Architect's Supplemental Instructions

Architect's ASI No: 030

Project:
Webster University
Interdisciplinary Science
Building

Description:

E0103.B

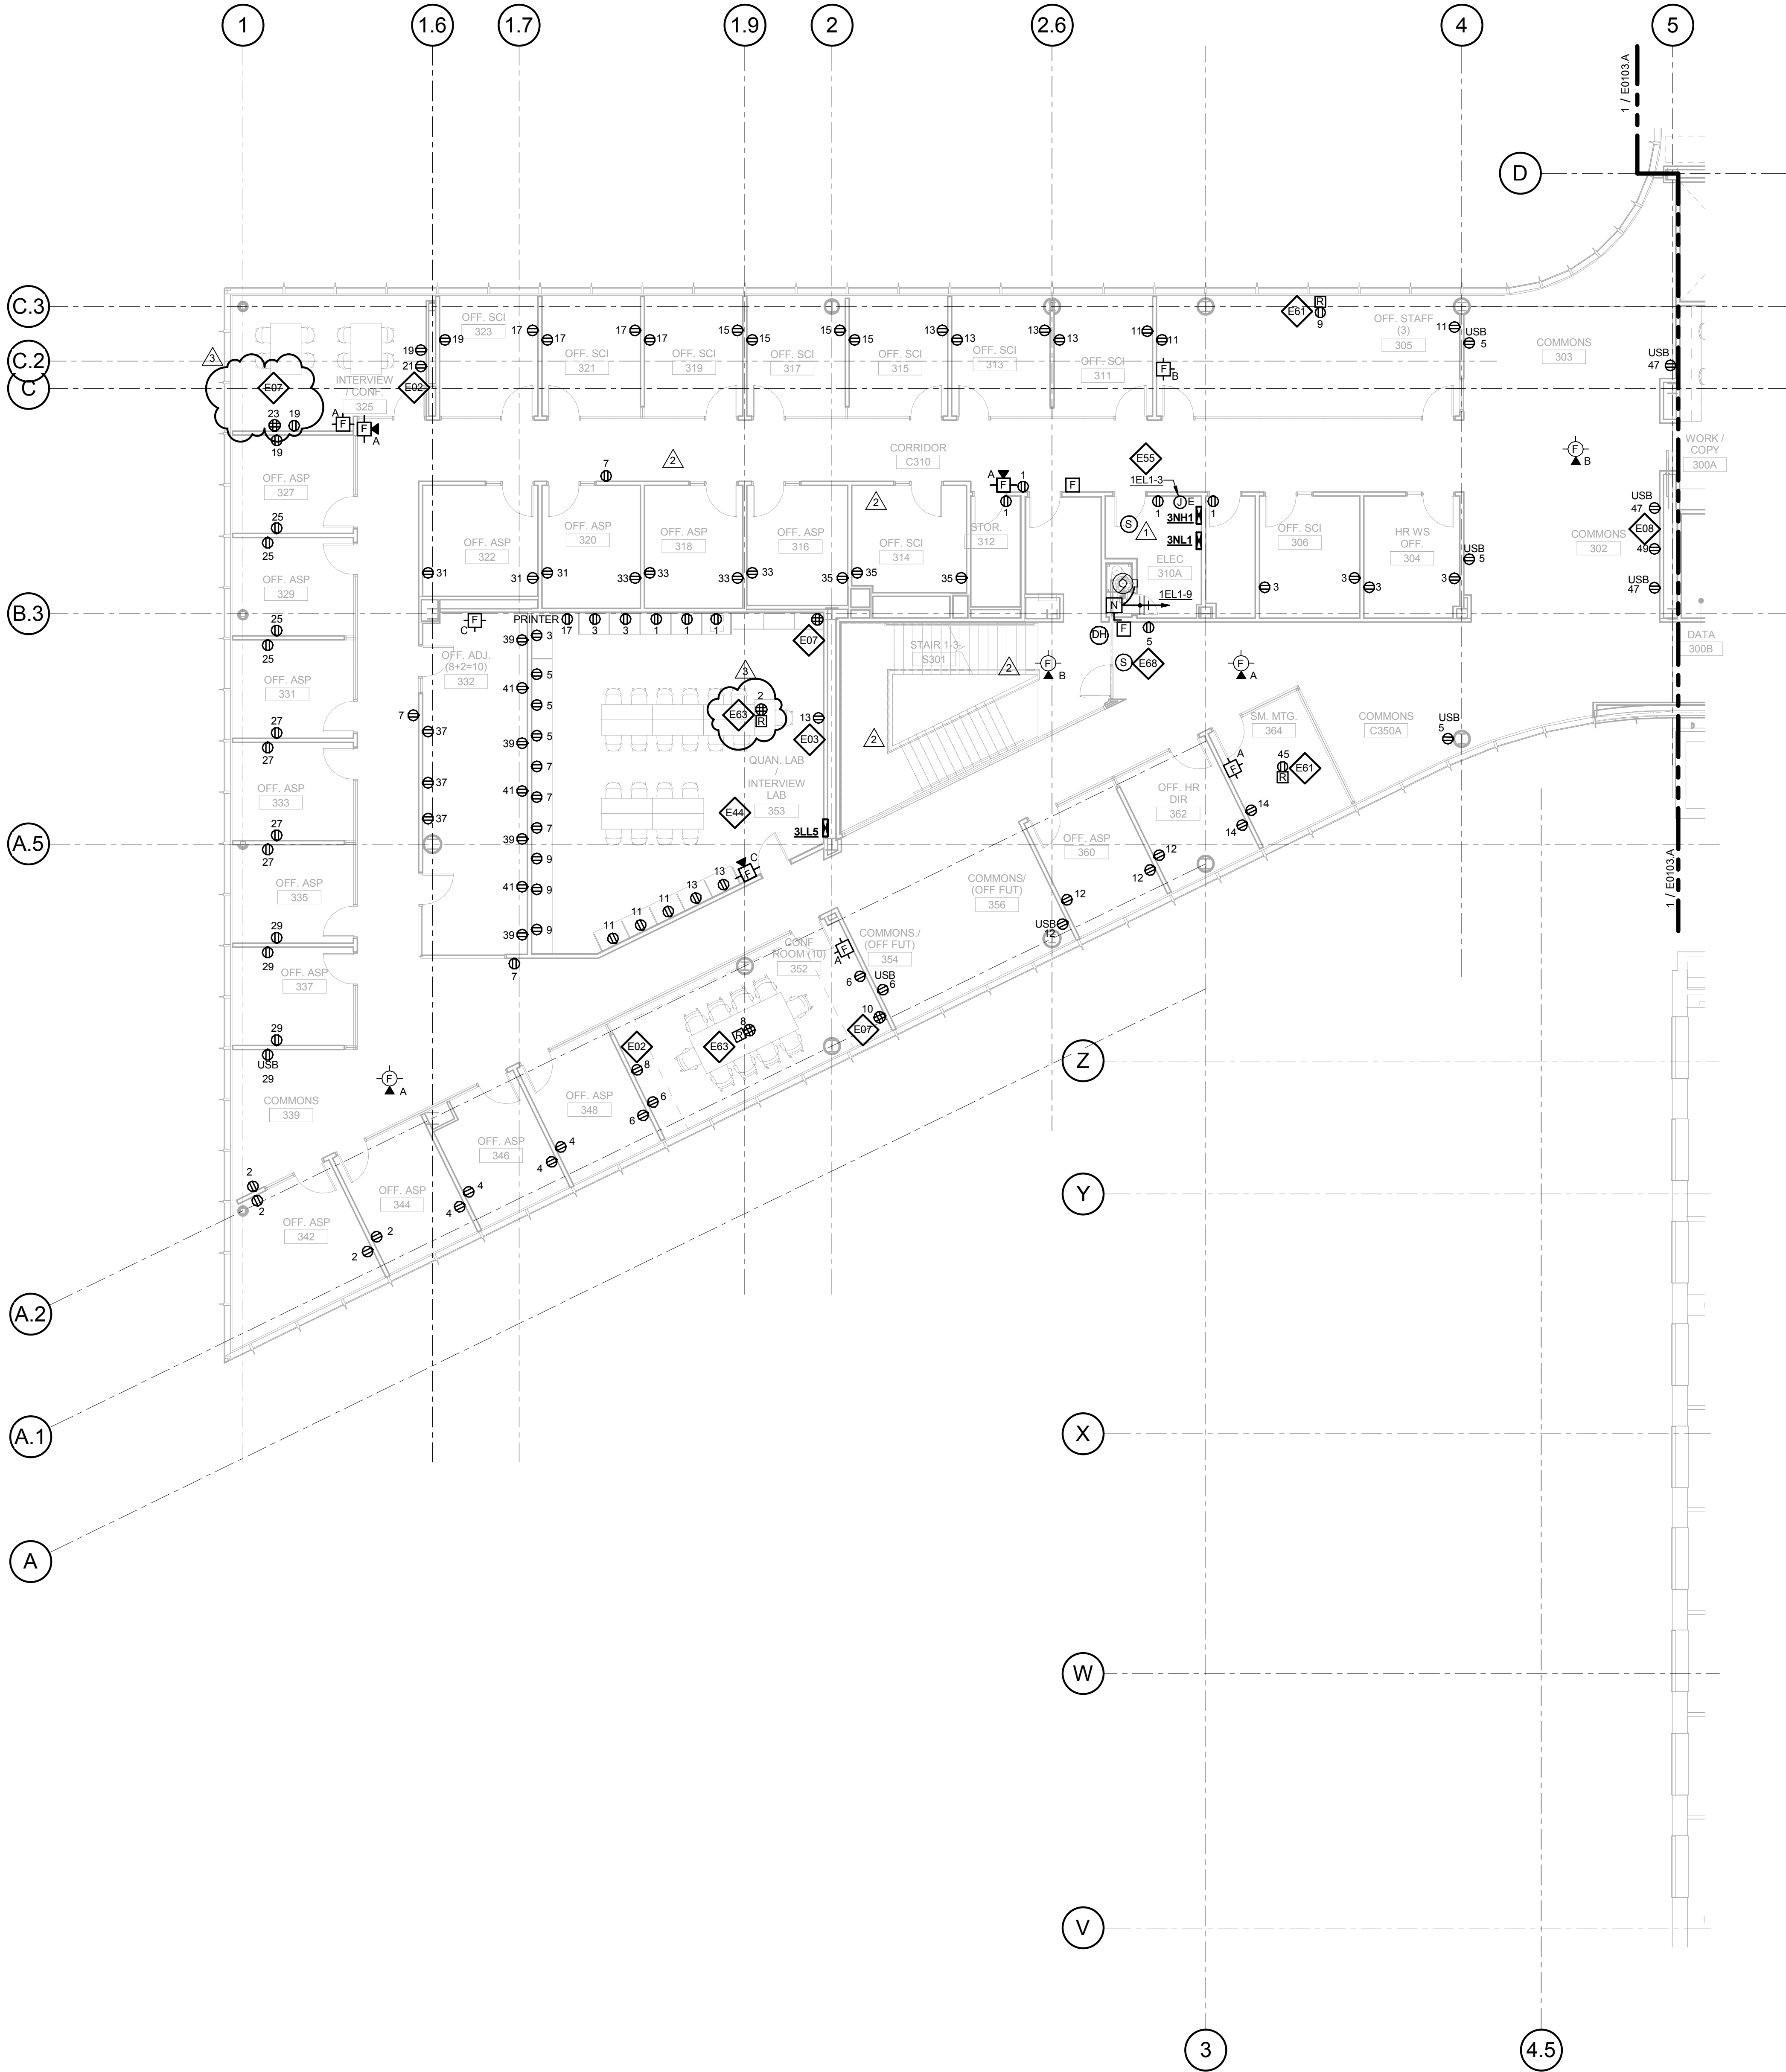
- B. In Room 156, add floor box and associated Keyed Note E63. Circuit as indicated.
7. E0103.B LEVEL 03 AREA B FLOOR PLAN – ELECTRICAL & AUXILIARY
 - A. In Room 325, move quadruplex receptacle on south wall east to match AV location.

- B. In Room 353, add floor box and associated Keyed Note E63. Circuit as indicated.
8. E0104.B LEVEL 04 AREA B FLOOR PLAN – ELECTRICAL & AUXILIARY
 - A. In Room 419, delete wall mounted projector duplex receptacle and associated Keyed Note E02.
